**Subject: Comments on Tentative NPDES Permit No. CA0055531  
City of Burbank Water Reclamation Plant**

**ENCLOSURE A: DETAILED COMMENT MATRIX FOR BURBANK WRP TENTATIVE PERMIT - JANUARY 2017**

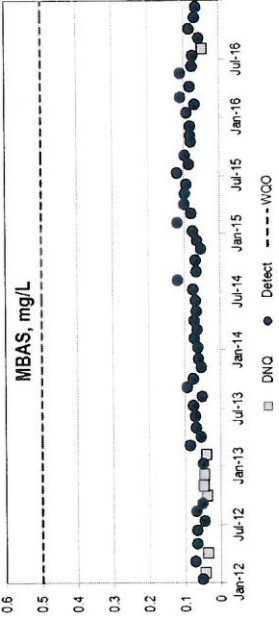
2.	Tentative Order, Section IV.A.1.a, Table 4 – Final Effluent Limitations, page 4 ; Attachment F, Section IV.D.3., Table F-13 Page F-60	Effluent Limitations without Reasonable Potential	<p>The proposed permit contains effluent limitations without a demonstrated calculation of reasonable potential (RP), including, radioactivity constituents, oil &amp; grease, settleable solids, chloride, sulfate, and MBAS. For constituents not regulated by the SIP, no authority exists for BPJ-based limits where MEC&lt;WQO. As shown in the graphs below, no reasonable potential exists for radioactivity constituents, oil &amp; grease, settleable solids, chloride, sulfate, or MBAS to exceed a water quality objective. Therefore, these limits need to be removed prior to adoption. See SWRCB Order No. WQO-2003-0009 at pgs. 7-9.</p> <p>In addition, gross beta/photons emitters in millirems/year cannot be measured directly in wastewater. The gross beta/photons emitters calculation is based on Strontium (Sr-90) and Tritium parameter data and no data for these parameters was available to submit as part of the 2016 ROWD. The only (gross beta/photons emitters) result available to date is based on August 2016 monitoring data, was only 6.4% of the proposed limit, and would not have triggered RP relative to the limit.</p> <p>The State Water Resources Control Board (SWRCB) has held that "the antibacksliding exception for new information applies where new monitoring data indicate that the discharge of a pollutant does not have reasonable potential to cause or contribute to a water quality standards violation." SWRCB Order No. WQO 2003-0009 at p. 9. In that matter, it was stated that limits should not be maintained where the data did not indicate RP. Here, the Regional Board is using non-data justifications for including effluent limits, which are not required. All effluent limits that do not have data demonstrating RP should be removed.</p> <p>The following charts demonstrate that Burbank's effluent is well below the applicable WQOs represented by the dashed line:</p>
